RE: EOR Response to the Written Comments of Atlantic Richfield Company (ARCO) Relating to DEIS

Montana Resources, LLP (MR) requested comments from the Engineer of Record (EOR) of the Yankee Doodle Tailings Impoundment (YDTI) in relation to the May 2, 2019 letter (ARCO letter) from Patricia Gallery (ARCO VP) to Mr Craig Jones (Department of Environmental Quality, DEQ). The ARCO letter provides written comments from Atlantic Richfield Company (ARCO) on the Draft Environmental Impact Statement (DEIS) prepared by DEQ in relation to the planned continued use of the YDTI. The MR request was initiated by a letter from Dan Walsh of the DEQ to Mark Thompson of MR on June 4, 2019, which requested a written response from the EOR and Independent Review Panel (IRP) in relation to comments contained in the ARCO letter.

Figure 1 Number of YDTI Instrumentation and Monitoring Locations since 2012

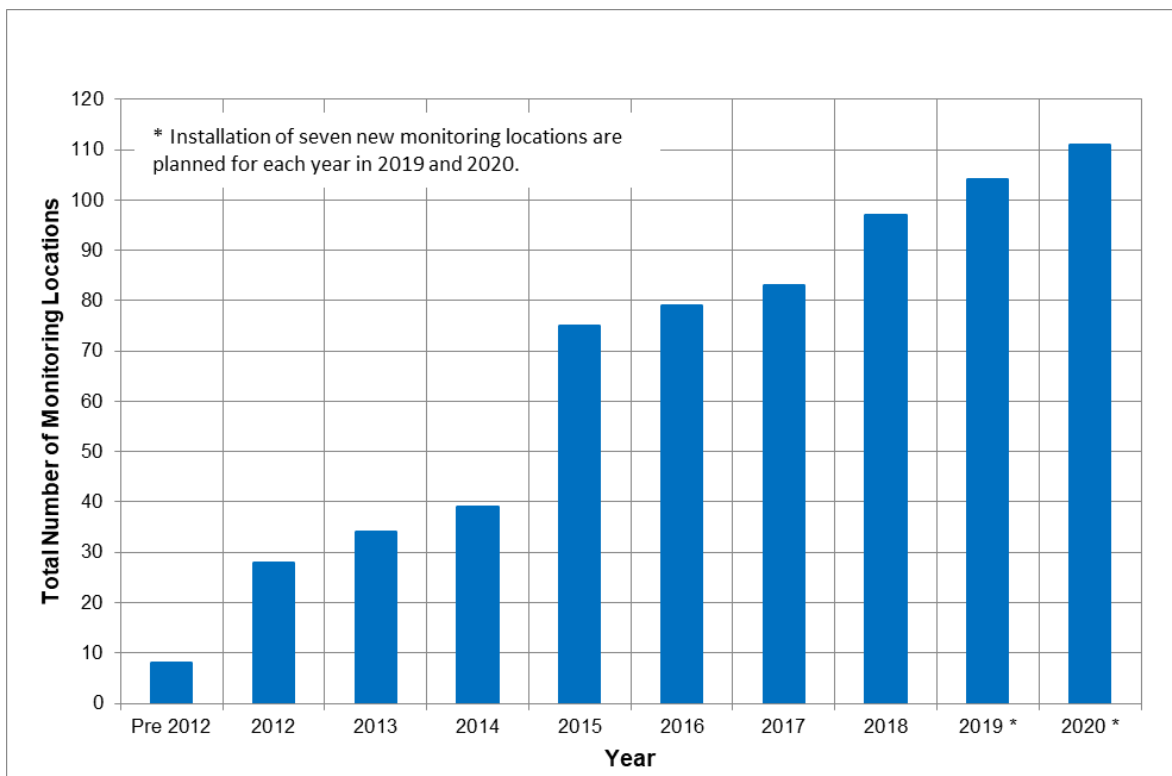
ARCO's inference that the embankment stability and the current monitoring systems at the YDTI are inadequate and inconsistent with the legislated requirements, as outlined in MCA 82-4-375 and 376, is

incorrect. It seems that ARCO and their retained technical consultants are unaware or unfamiliar with the data collection, real-time monitoring and warning systems that are currently in operation and the plans for the progressive upgrading, modification and expansion of the monitoring systems as part of the continuous improvement processes that are being implemented at the YDTI. Figure 1 provides a summary of the number of piezometric monitoring locations added since 2012. Most of the monitoring locations installed since 2015 are outfitted with nested piezometer installations, and approximately 225 monitoring instruments at over 100 sites are providing real-time data through the RMS. All new piezometric monitoring sites, beginning in 2018, are integrated directly with the RMS during installation.
